SUBJECT: CERTIFICATION OF THE MINUTES OF THE ACRS APR 1400
SUBCOMMITTEE ON NOVEMBER 29, 2016, ROCKVILLE,
MARYLAND

ADVISORY COMMITTEE ON REACTOR SAFEGUARDS
MINUTES OF THE APR1400 SUBCOMMITTEE MEETING ON
NOVEMBER 29, 2016, ROCKVILLE, MD

Chapter 8: Electric Power System

Response to the ACRS Subcommittee Questions on Chapter 2, 5, 10 and 11

8.2 Offsite Power System

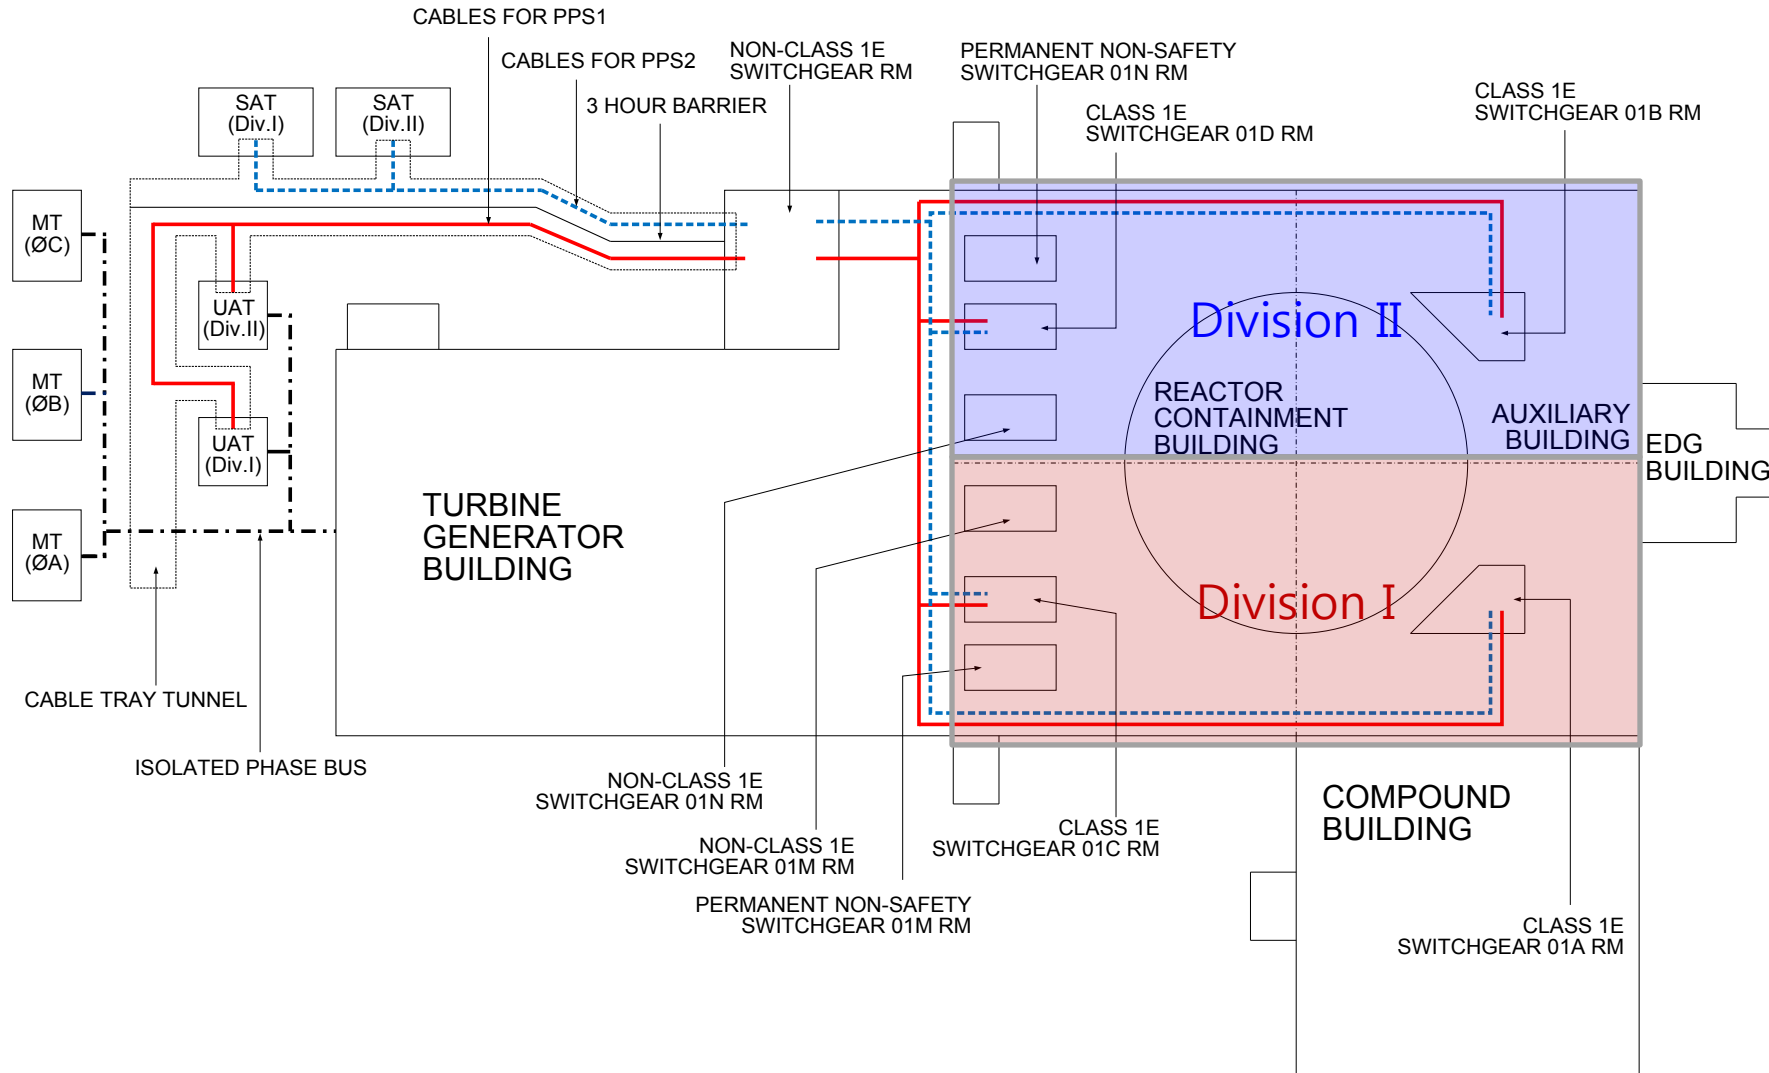
MEMBER STETKAR: Alex, before you switch this, there's some areas in and around the aux building where you show the normal and preferred PPS circuits, the blue and the red together. I see that there's a wall between them in the underground ducts from the transformers to the switchgear room. In the DCD, it only says that separation is maintained by dedicated cable trays. Are the normal and alternate preferred sources routed through the same fire zone after they exit the Non-Class 1E switchgear room and

MEMBER STETKAR: I understand. I'm just trying to understand how they're actually routed, so they are routed through the same fire zone. Can you show me -- I know where the AAC GTG building is located. It's down somewhere over by Rob. How are the cables from -- where is Bus 3N located?

MR. KANG: Good questions. Inside of the building, PPS I circuit and PPS II circuit are separated by different cable trays.

Figure 2.0-1 Horizontal Certified Seismic Design Response Spectra

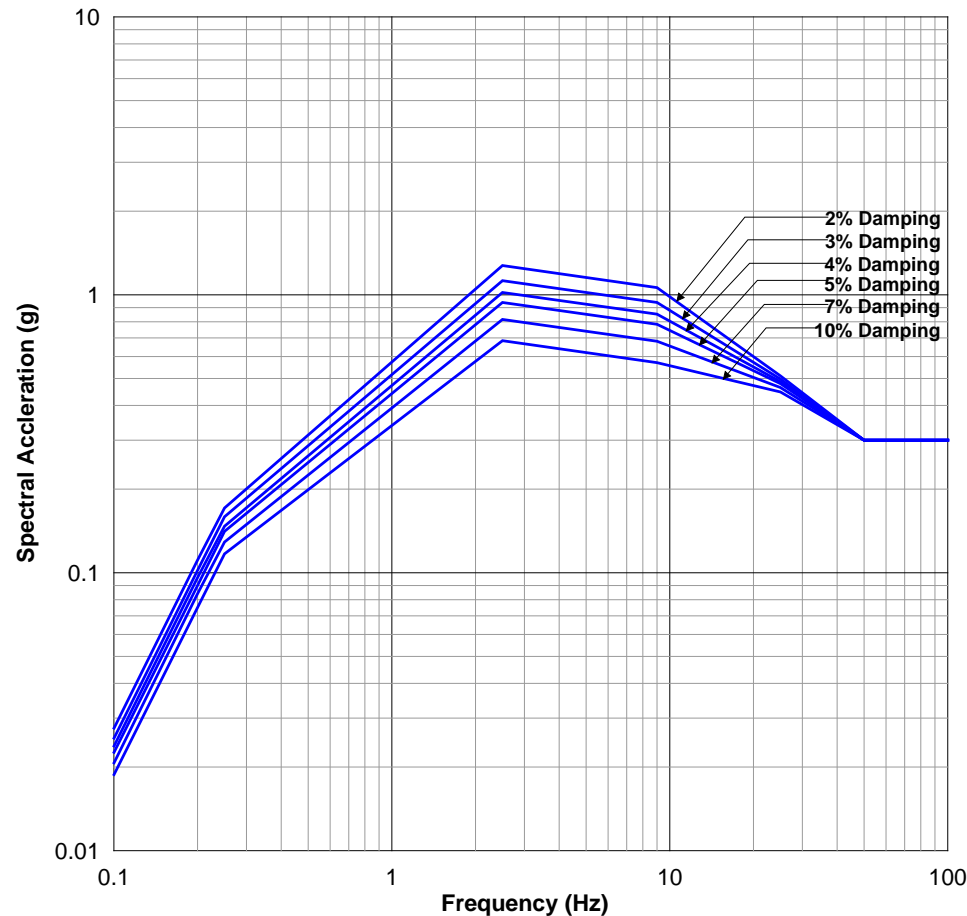
The point of the degradation, below-grade concrete degradation, for this issue, there is no ground water chemistry limitation in the DCD revision, but it has been added in the DCD through the RAI responses, so there is added in the DCD. The RAI 227-8274, Question No. 03.08.04-9. There is a simple and straightforward concern about the label, so the Figure 2.0-1 and 2.0-2 doesn't have the appropriate labels.

We're going to add the label in the associated picture. There is a question about the DC scope and out of scope of work in terms of the seismic design. The seismic design, the design certification scope is limited to the reactor containment building and auxiliary building and EDG and DFOT building, as are required in the DCD Figure 1.2-1. There is not any currently general DCD. There is actually -- there's a note identifying this configuration added through RAI responses. Probably, you can see the appropriate description in the RAI Response 8299, Question 03.07.02-15. There was concern about the re-entry building settlement between the nuclear island
